## Environmental Planning Commission

Agenda Number: 07  
Project Number: 1004675  
Case #: 16EPC-40013  
April 14, 2016

### Staff Report

<b>Agent</b>	Modulus Architects, Inc.
<b>Applicant</b>	Rain Tunnel Car Spa
<b>Request</b>	<b>Site Development Plan for Building Permit</b>
<b>Legal Description</b>	Tract J, Plat for Vista de La Luz
<b>Location</b>	At 5401 Sevilla Ave. NW, between Coors Blvd. and Costa Almeria Dr. NW
<b>Size</b>	Approximately 1.9 acres
<b>Existing Zoning</b>	SU-1 / O-1 & C-1 Permissive Uses with Exclusions
<b>Proposed Zoning</b>	No Change

Sheet Title:  
**Landscape Plan**

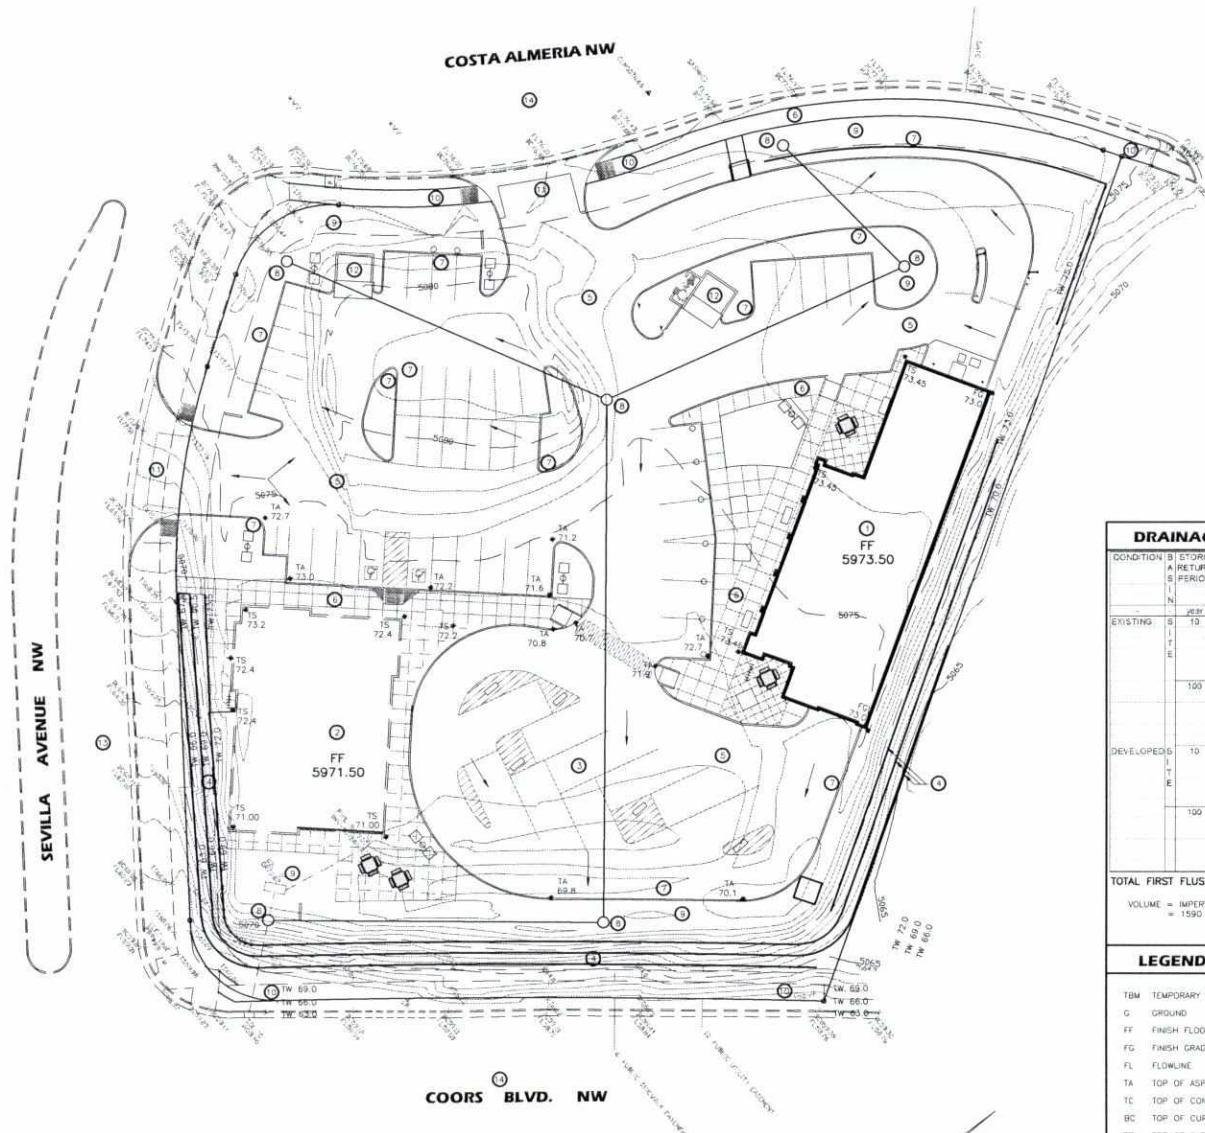
Staff also notes that the subject site's orientation on the site plan sheets will need to be standardized throughout the site development plan set. The site plan and landscape plan sheets show the north arrow pointing to the right, while the conceptual grading/drainage and utility plan show the north arrow pointing up. The site plan and landscape plan sheets need to be amended to point north.

The total required landscape net lot area coverage for the site is 11,446 sf and the applicant is proposing 24,771 sf which exceeds the requirement. In addition, 75% of the net lot area must include live plant coverage which equates to 8,585 sf and the applicant is only proposing 8,505 sf of live plant coverage which does not meet the minimum requirement. The landscape plan will need to be revised to show the correct amount of live plant coverage square footage.

2. Prior to application submittal to the DRB, the applicant shall meet with the staff planner to ensure that all conditions of approval are met.
3. Additional buffer landscaping that conforms to the approved Vista de La Luz Site Development Plan for Subdivision (VLLSDPS) shall be included along Costa Almeria Dr.

9. The landscape plan will need to be revised to show 7 street trees to comply with the City of Albuquerque Street Tree Ordinance (6-6-2-5, Street Tree Policies).

10. The landscape plan will need to be revised to show the correct amount of live plant coverage square footage, as it currently indicates that the landscape plan does not meet the minimum requirements of the zoning code.

4. The site plan and landscape plan sheets shall be amended to point north to match the layout of the conceptual grading/drainage and utility plan sheets.
